IREDELL COUNTY HEALTH DEPARTMENT - *ENVIRONMENTAL HEALTH* ☐ STATESVILLE OFFICE 704-878-5305 ☒ MOORESVILLE OFFICE 704-664-5281

IMPROVEMENT PERMIT / AUTHORIZATION TO CONSTRUCT / OPERATION PERMIT / EXISTING SYSTEM INSPECTION

PERMIT # 17072 PIN # 4614744342 DATE 4-30-2012

INITIAL SITE SKETCH

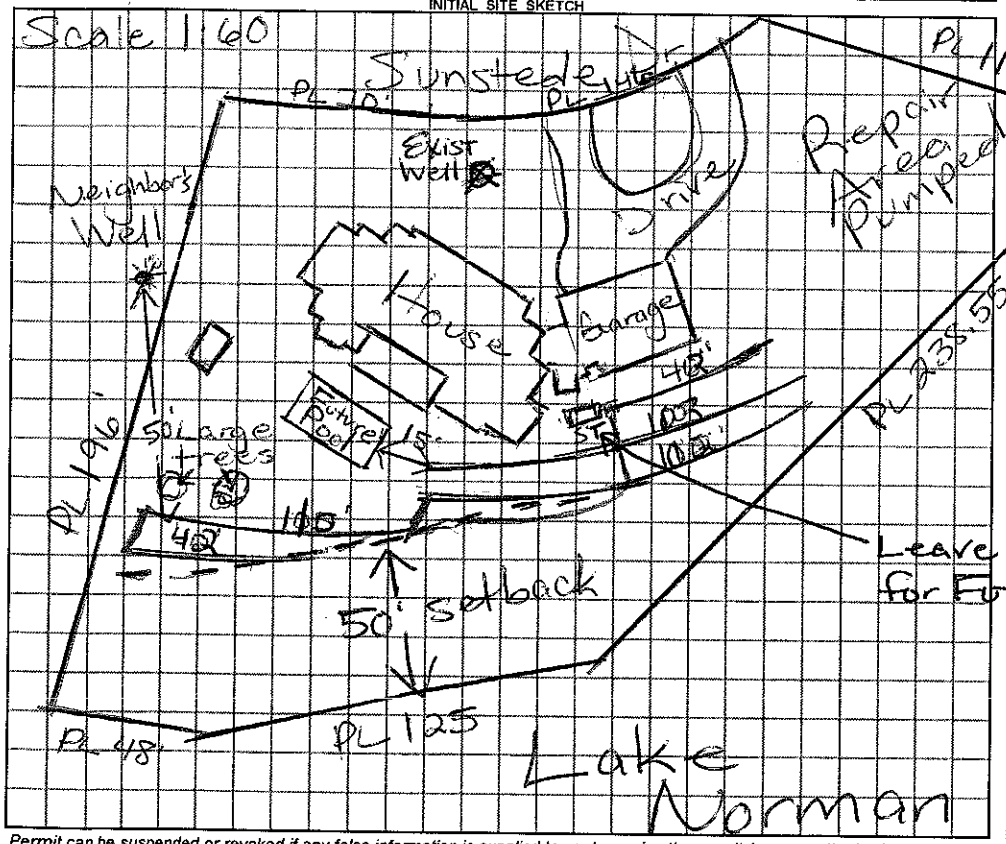
Comments / Conditions: Try to keep 24" trench bottom on Upper Trenches OK to be 36" on lower Trenches. Keep Septic System 50ft from any well, 50ft from lake & 5ft from house

* Serial distribution on drainlines. (Use "multi-port") to center feed long lines. Keep Supply line at least 25ft to lake. Okay to end feed lines if preferred Note: Any Future Pool must be 15ft from Septic

Used Quick 4. Installed as Drawn
